<b>Illinois Tollway Base Sheet Revisions</b>
--

Section M	Base Sheet Drawings	
Drawing	Modification Summary	Effective: 2019-03-01
<b>Pole Assembly (ITS)-Series 1000</b>		
M-ITS-1000	<b>Elevation Views Pole Mounted ITS Element Assembly</b> Changed disconnect switch to unfused.	
M-ITS-1003	<b>ITS Concrete Service Pad (2 sheets)</b> New drawing with three types of service pads for ITS poles for flat and slope installation.	
M-ITS-1004	<b>Cabinet Wiring Diagram - ITS Pole Mounted Enclosure (Solar Powered MVDS) (2 sheets)</b> New cabinet layout separating ITS enclosure and dedicated co-located solar generator/battery cabinet with four 6 V batteries.	
<b>Dynamic Message Sign (ITS)-Series 1100</b>		
M-ITS-1108	<b>DMS Cabinet Wiring Diagram</b> Changed to Cisco 4000 series switch. Changed IP Relay to DIN IV.	
<b>Cabinet Wiring (ITS)-Series 1200</b>		
M-ITS-1200 to M-ITS-1217	<b>Cabinet Wiring Diagrams</b> 18 new ITS enclosure drawings replace old 56 ITS enclosure drawings for clarification. Drawings 1200 to 1217 have been redone completely. Consolidated equipment configurations. Standardized to-scale equipment layout. Changed to Cisco 4000 series switch. Eliminated 24 VAC transformer and

RWIS POLE, SENSOR MOUNTING DETAIL

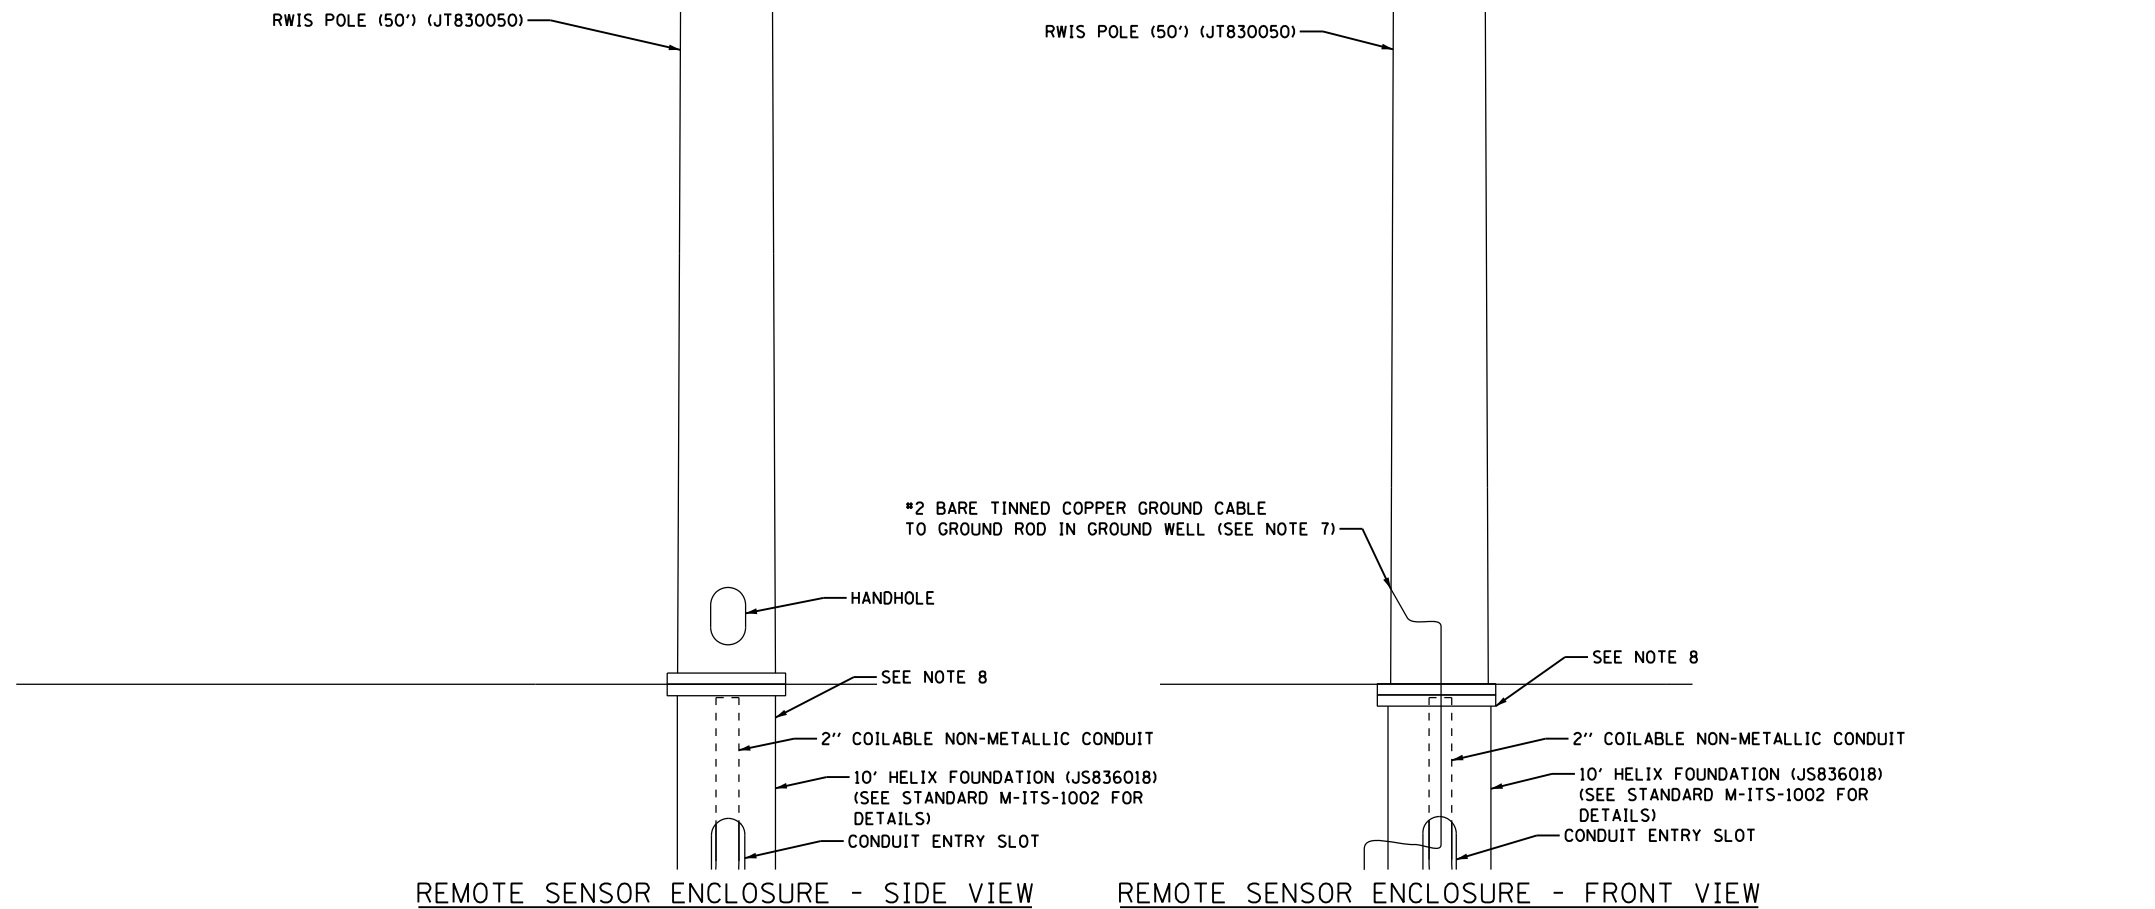
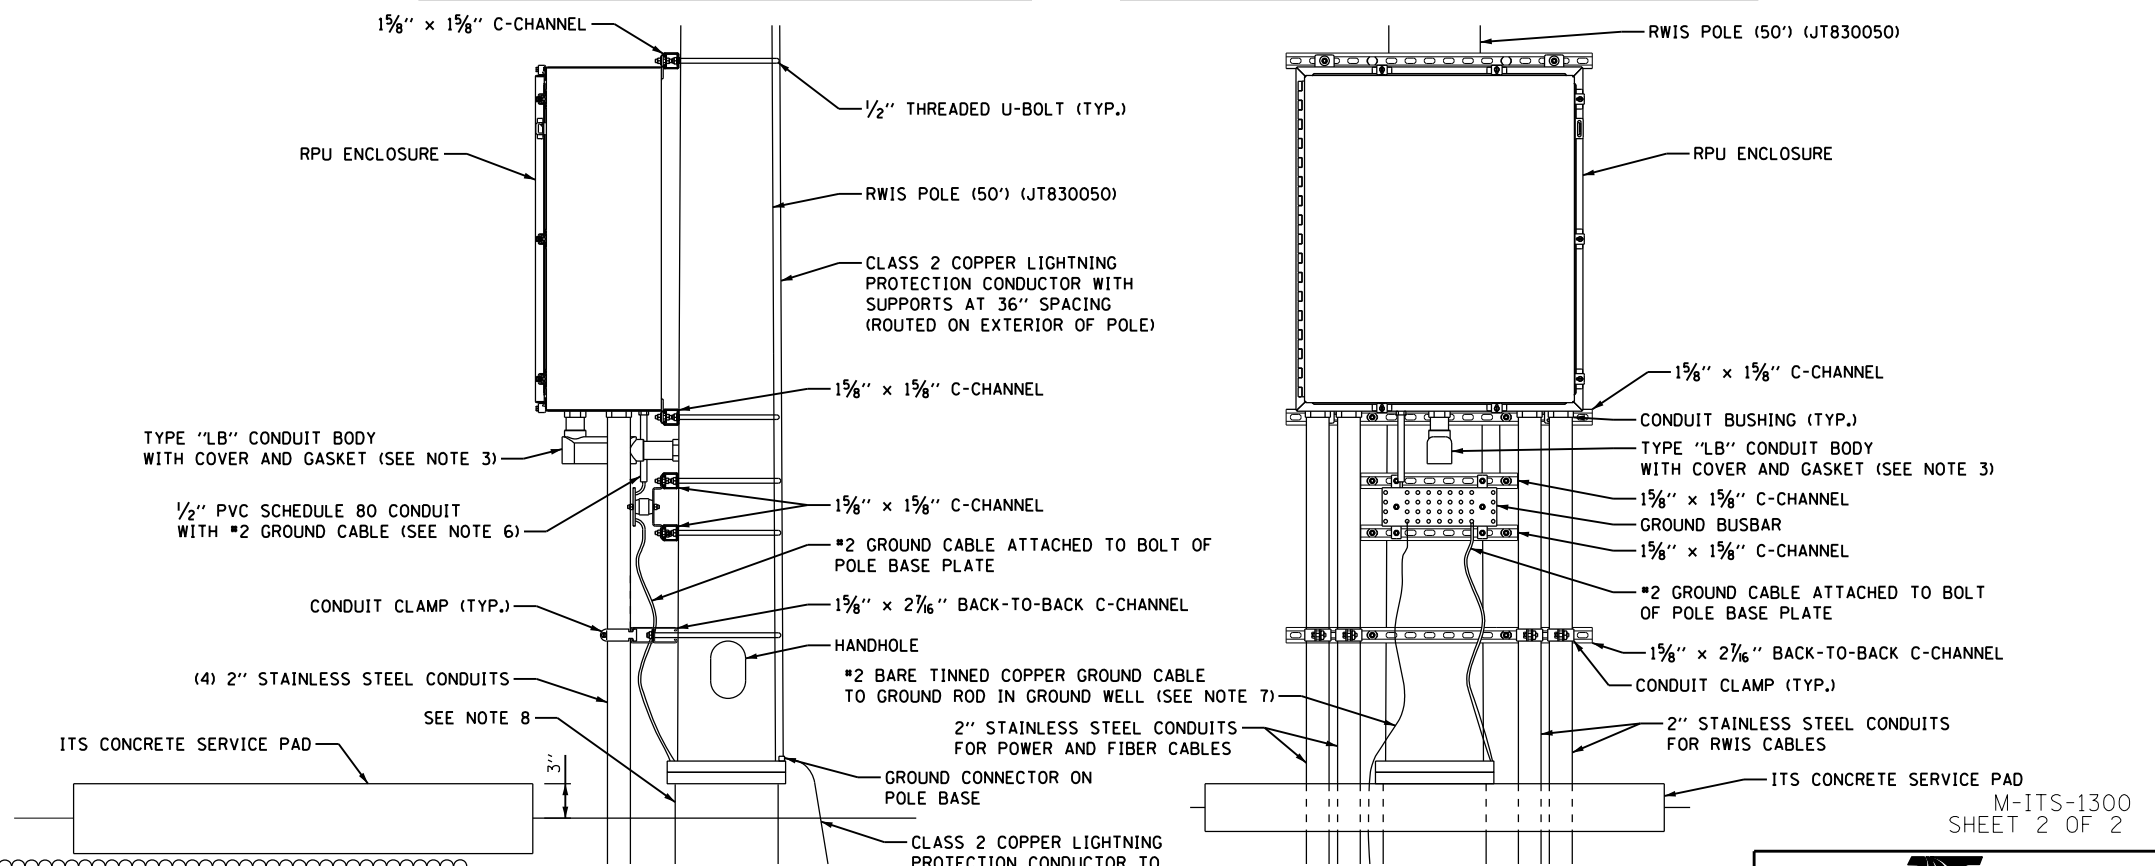
<del>M-ITS-12018 to M-ITS-1255</del>	<b>Cabinet Wiring Diagrams</b> Retired due to consolidation.	
<b>Roadway Weather Information System (ITS)-Series 1300</b>		
M-ITS-1300	<b>RWIS Pole, Sensor Mounting Detail</b> Pole height changed to 50 feet as standard pole for ITS with 17.5 inch bolt circle.	
M-ITS-1301	<b>RWIS Cabinet Wiring Diagram</b> Changed to Cisco 4000 series switch. Not connected to RWIS controller, for future use. Added IP Relay. Disconnected, for future use. Added secondary sensor pole cabinet wiring diagram. Cabinet is part of the design but was omitted in last year release.	
M-ITS-1303	<b>Typical RWIS Grounding Schematic</b> New drawing showing RWIS grounding system with grounding cable.	
<b>Solar Powered Generator (ITS)-Series 1400</b>		
<del>M-ITS-1402</del>	<b>Pole Mounted Solar MVDS Assembly</b> Co-located solar generator cabinet redesigned as M-ITS-1004.	
<b>Tower Mounted CCTV (ITS)-Series 1500</b>
